Access Compliance Report

Public Rights-of-Way

(Curb Ramps)

Intersection ID: 53418	Main Street: SOUTHGROVE_ST	Cross Street: ARDREY_KELL_RD	Location: SE
ADA ID: 1E6978F5B9F2	Ramp Type: BlendTrans1	Initial Pass/Fail: Pass	Overall Compliance: No
		Severity Score: 5.25

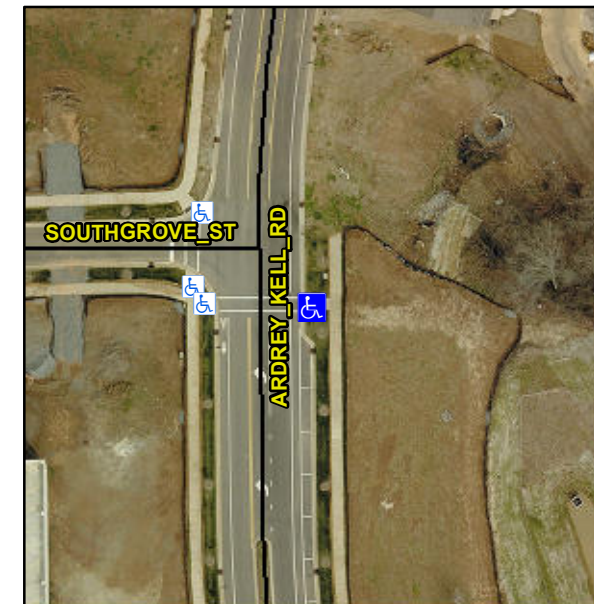
Remove & Replace Curb Ramp With Two New Directional Ramps or Equivalent. Remove & Replace Gutter.

Not Found, R304.5.3, R304.5.4
